ATTACHMENT I

PROPOSED TECHNICAL SPECIFICATION CHANGES  
RELATED TO  
SAFETY REVIEW COMMITTEE REORGANIZATION

POWER AUTHORITY OF THE STATE OF NEW YORK  
JAMES A. FITZPATRICK NUCLEAR POWER PLANT  
DOCKET NO. 50-333

ATTACHMENT II  
SAFETY EVALUATION  
RELATED TO  
SAFETY REVIEW COMMITTEE REORGANIZATION

Figure 5.2-2  
 Management Organization-Offsite  
 Radiological Environmental  
 James A. FitzPatrick Nuclear  
 Power Plant

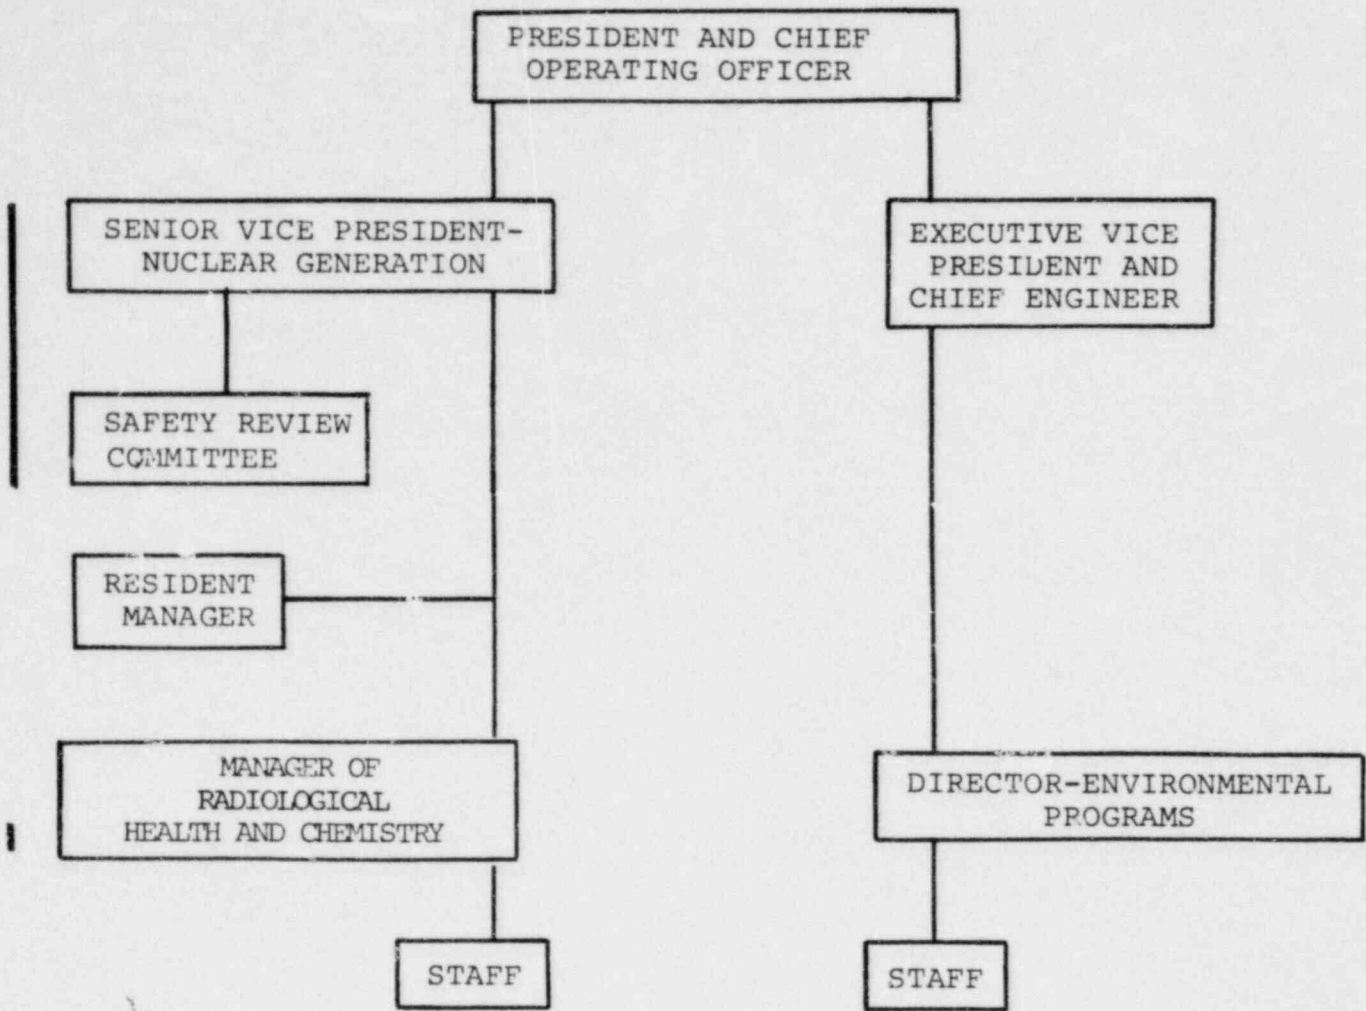
The proposed changes to Appendix A (Technical Specifications) of the James A. FitzPatrick Operating License seeks to amend Section 6.5.2, "Safety Review Committee (SRC)." The proposed changes make the Safety Review Committee reportable to the Senior Vice President - Nuclear Generation. Previously, the SRC reported to the President and Chief Operating Officer. The change to pages 252a, 253 and 259 is, in essence, a replacement of the word 'President' with 'Senior Vice President - Nuclear Generation.' Similarly, Figure 6.1-1 (Management Organization Chart) on page 259 of Appendix A and Figure 5.1-2 (Management Organization - Offsite Radiological Environmental) on page 44 of Appendix B is revised to show the SRC reporting to the Senior Vice President - Nuclear Generation. In addition, the titles of the SRC members have been changed to reflect the recent Authority headquarters office reorganization. The SRC quorum has been changed to agree with the Commission's standard technical specifications.
